**SITE PLAN REVIEW SHEET
ENVIRONMENTAL VARIANCE REQUEST ONLY**

CASE: SP-2021-0446D

PROJECT NAME: 8020 Parmer SH 130 NW

DESCRIPTION OF VARIANCES:

CUT - FILL PLAN

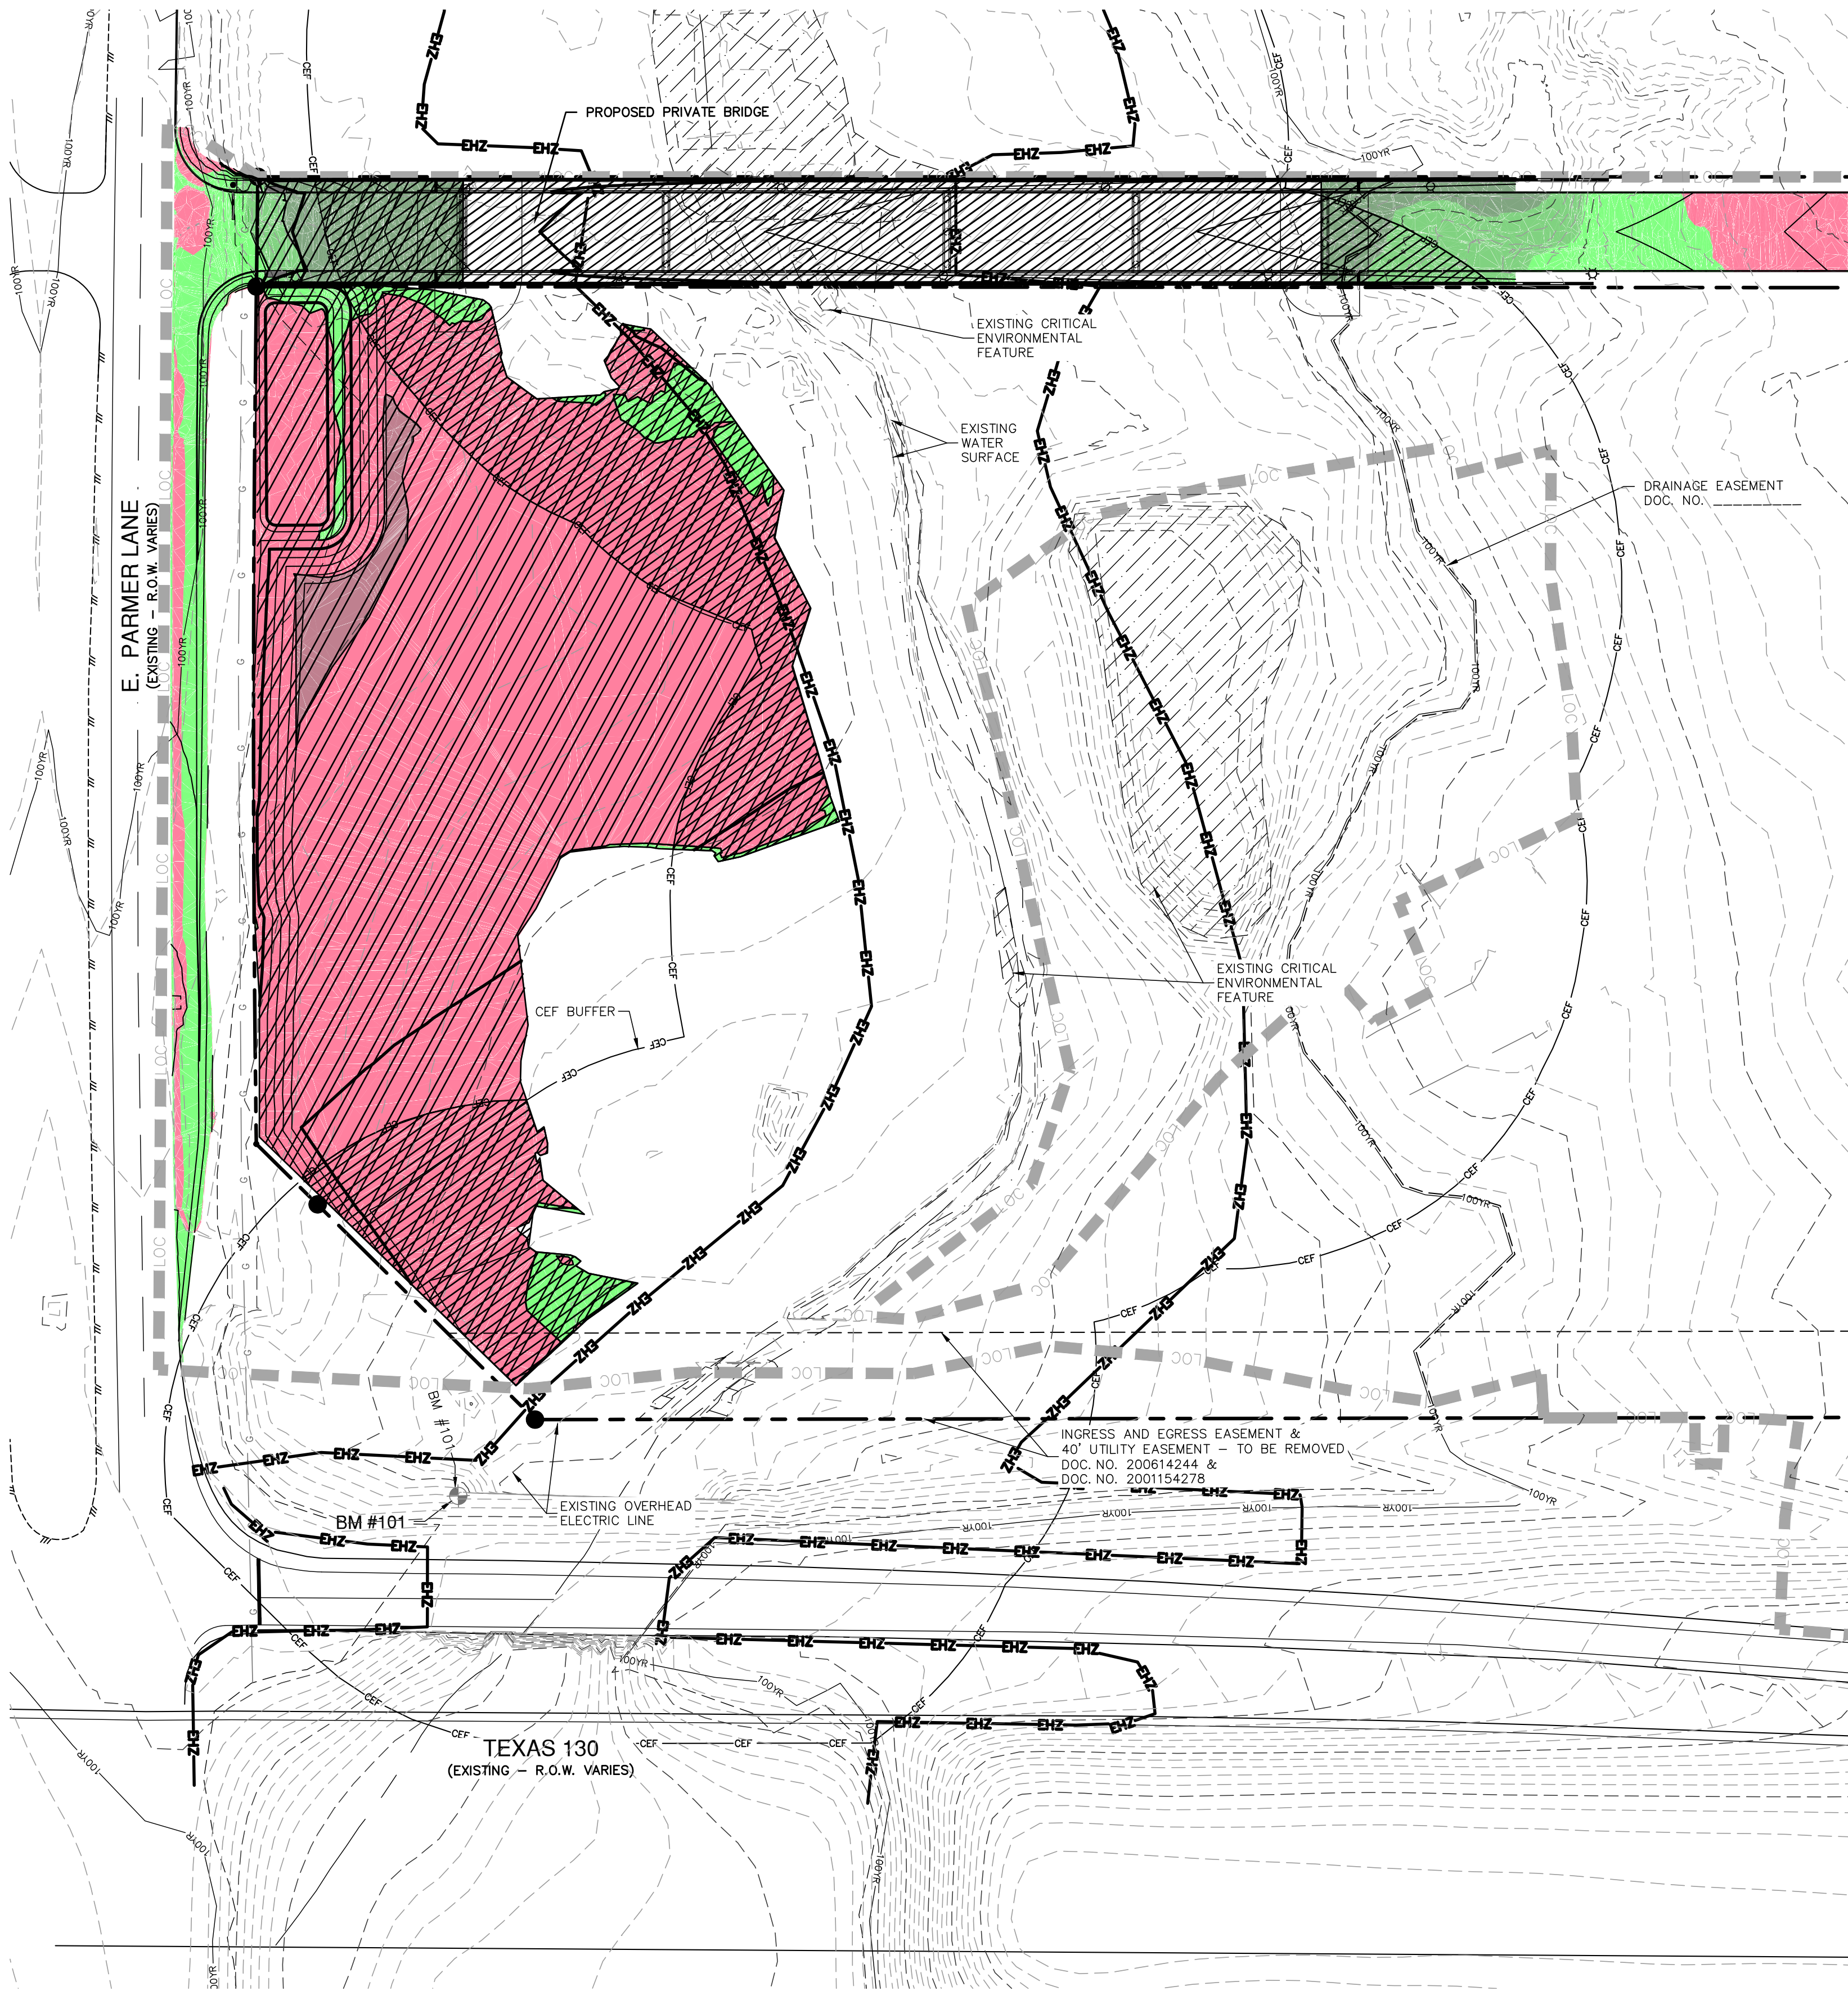
- 1) Vary from LDC 25-8-342 to allow fill over 4 feet to 15 feet.
- 2) Vary from 25-8-261(G) to allow floodplain modification in a critical water quality zone buffer.

The fill variance is required in order for the applicant to access the site with a bridge spanning wetlands, floodplain, and creek buffer.

The findings of fact have been met, and staff recommends approval for fill over 4 feet to 15 feet and floodplain modification in a critical water quality zone buffer, with the following conditions:

SHEET TITLE
Wetland
Mitigation

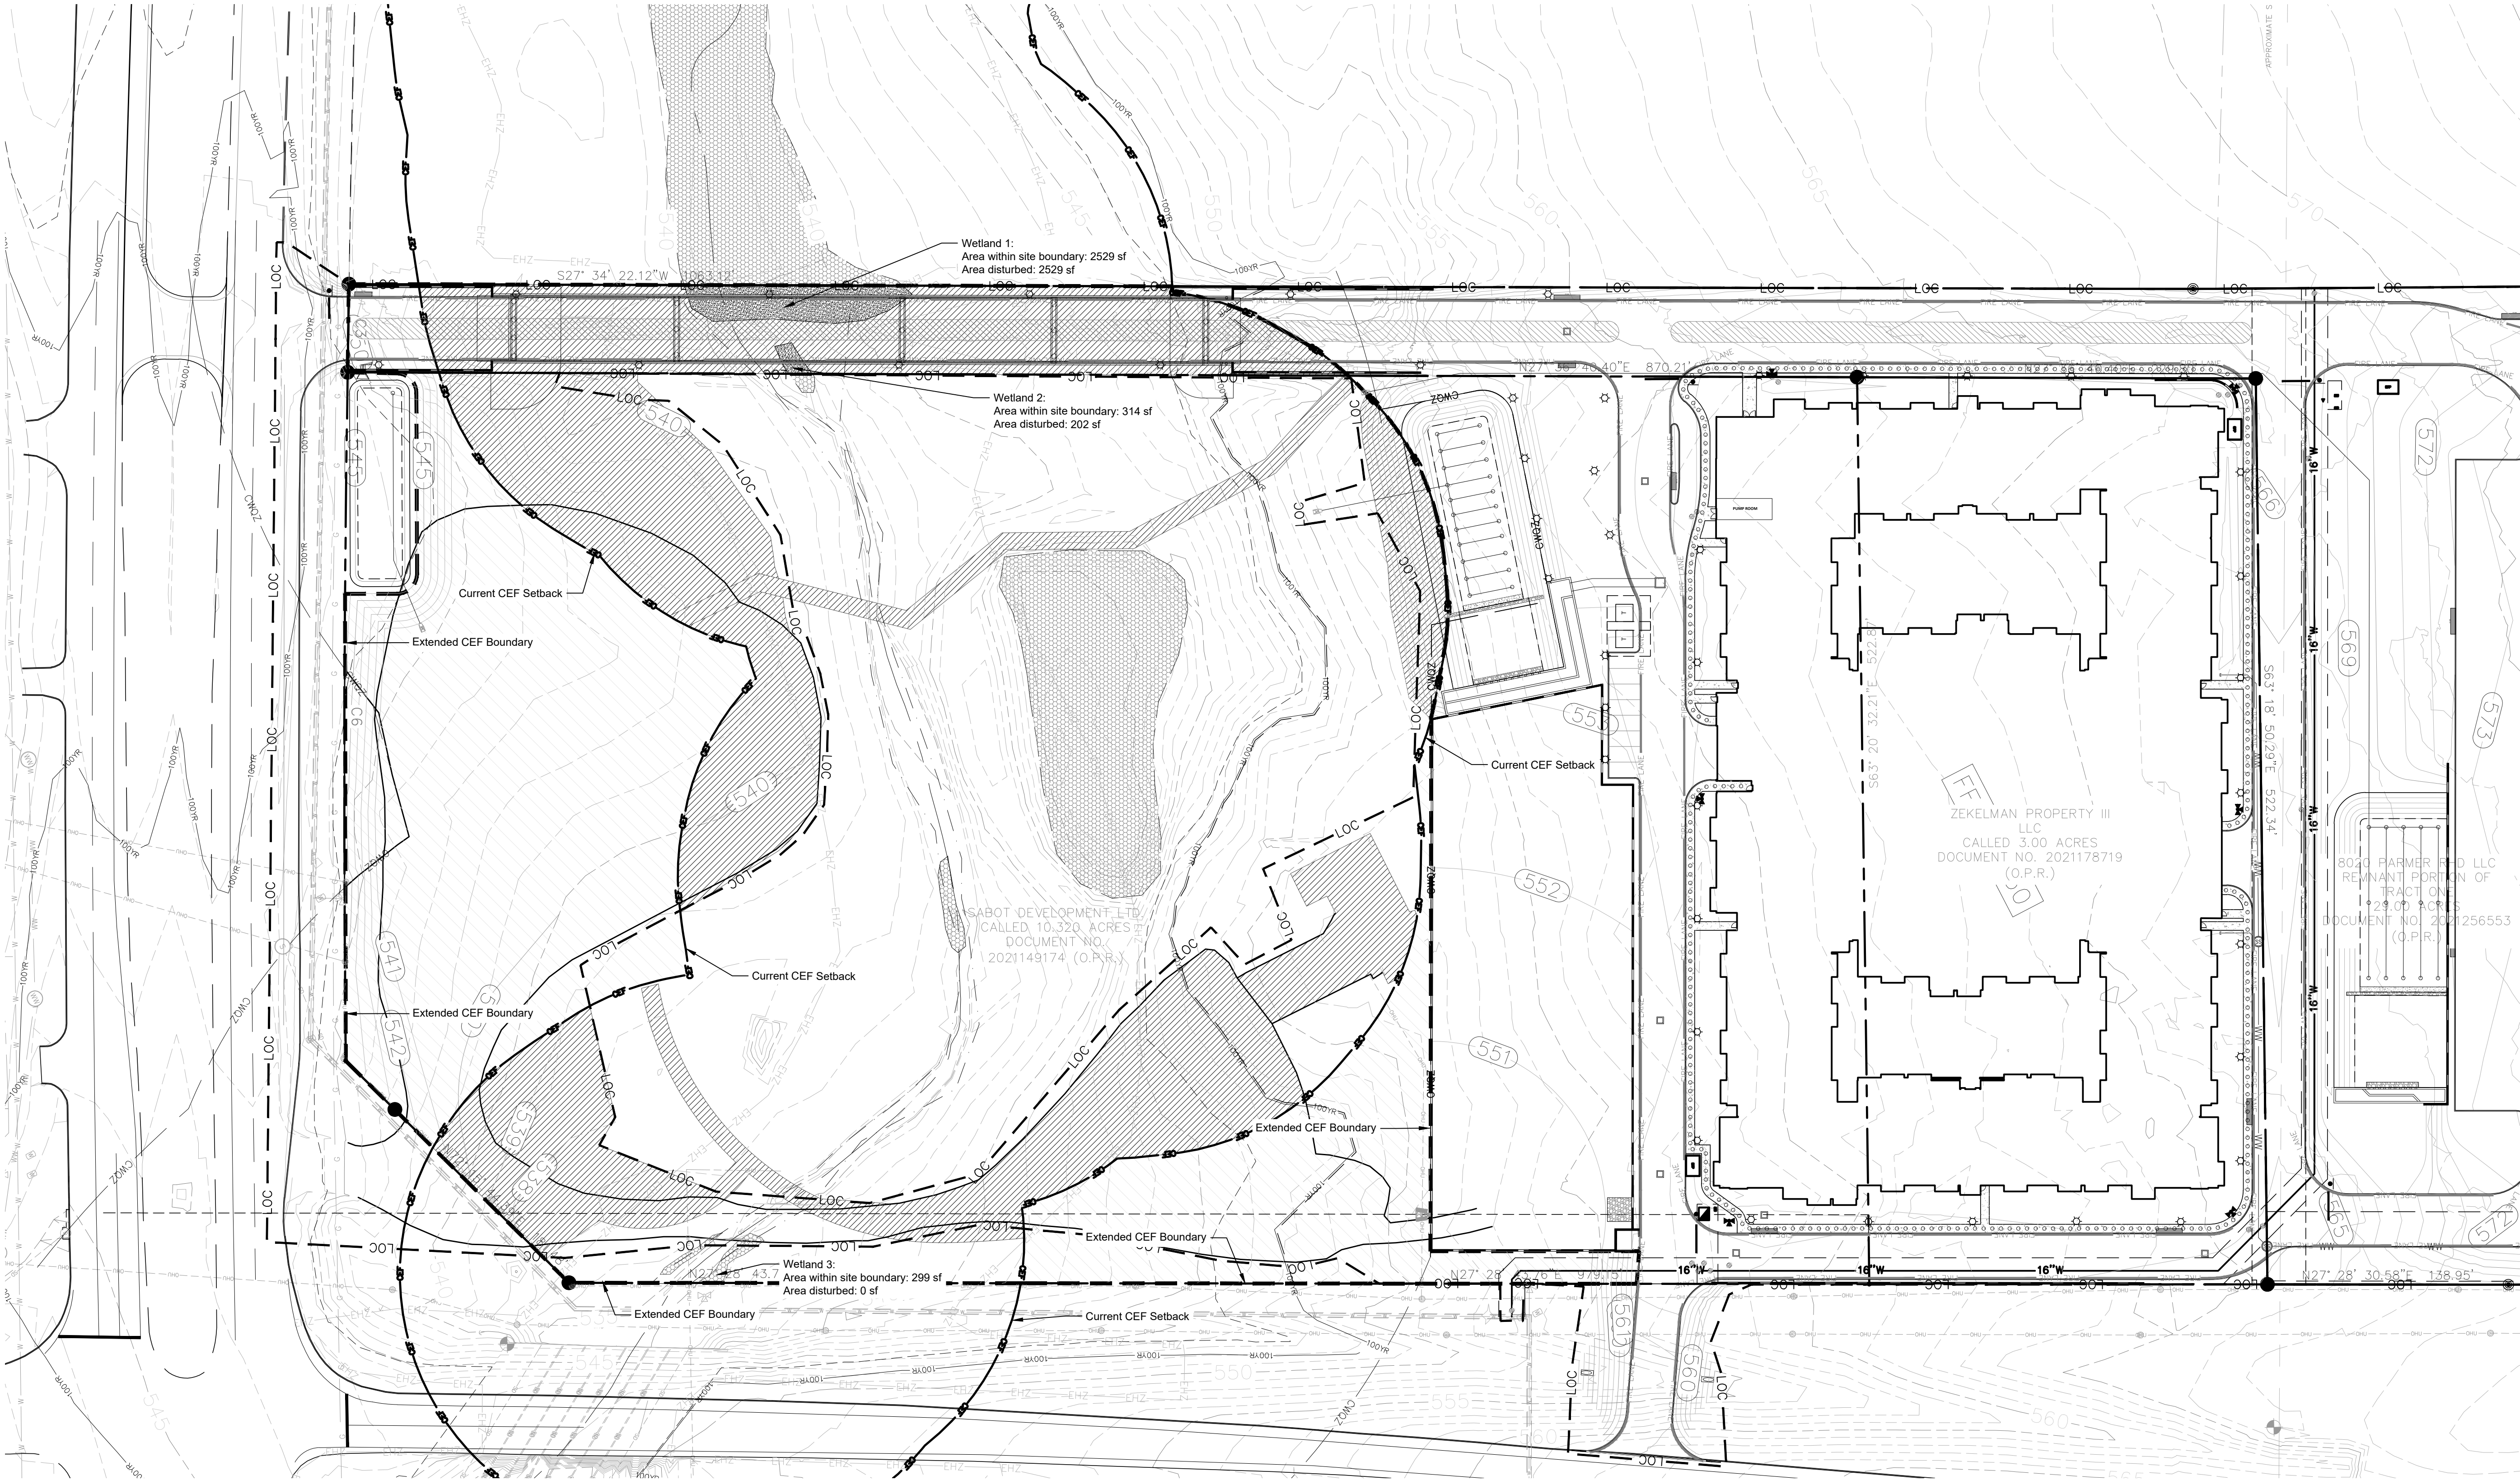
Yes A flood study has been completed and reviewed by the City of Austin to prove no adverse impact to other properties. The bridge piers have been placed to minimize the impact to the waterway and existing wetland CEFs. Existing impervious cover in the CEF and CWQZ will be removed, and a CEF mitigation and floodplain mitigation plan has been proposed and reviewed by City of Austin staff.

1. The applicant will pay into the Riparian Zone Mitigation Fund for both the area of Zone 1 (Floodplain outside of the CWQZ) and the area of Zone 2 (Floodplain within the CWQZ) using the appropriate ratios per ECM 1.7.6.
2. Development of the site will be carried out as described in Exhibits 1-6, attached in the staff variance packet.
